PCN# 20240429001.1

**Qualification of RFAB using qualified Process Technology, Die Revision and additional Assembly BOM options for select devices
Change Notification / Sample Request**

Date: April 30, 2024

Sample product shipping label (not actual product label):

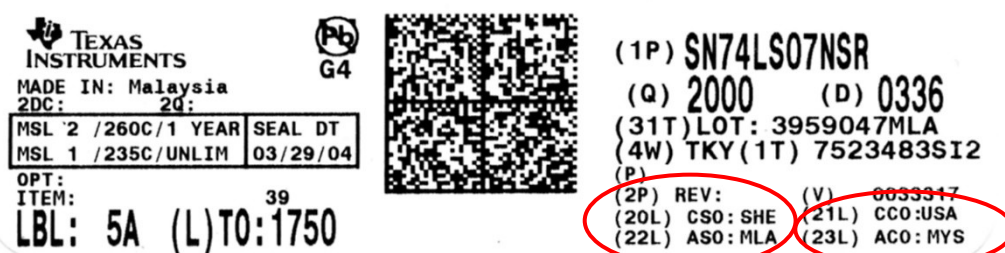
Changes to product identification resulting from this PCN:**Fab Site Information:**

Chip Site	Chip Site Origin Code (20L)	Chip Site Country Code (21L)	Chip Site City
DL-LIN	DLN	USA	Dallas
RFAB	RFB	USA	Richardson

Die Rev:**Current****New**

Die Rev [2P]	Die Rev [2P]
A	A
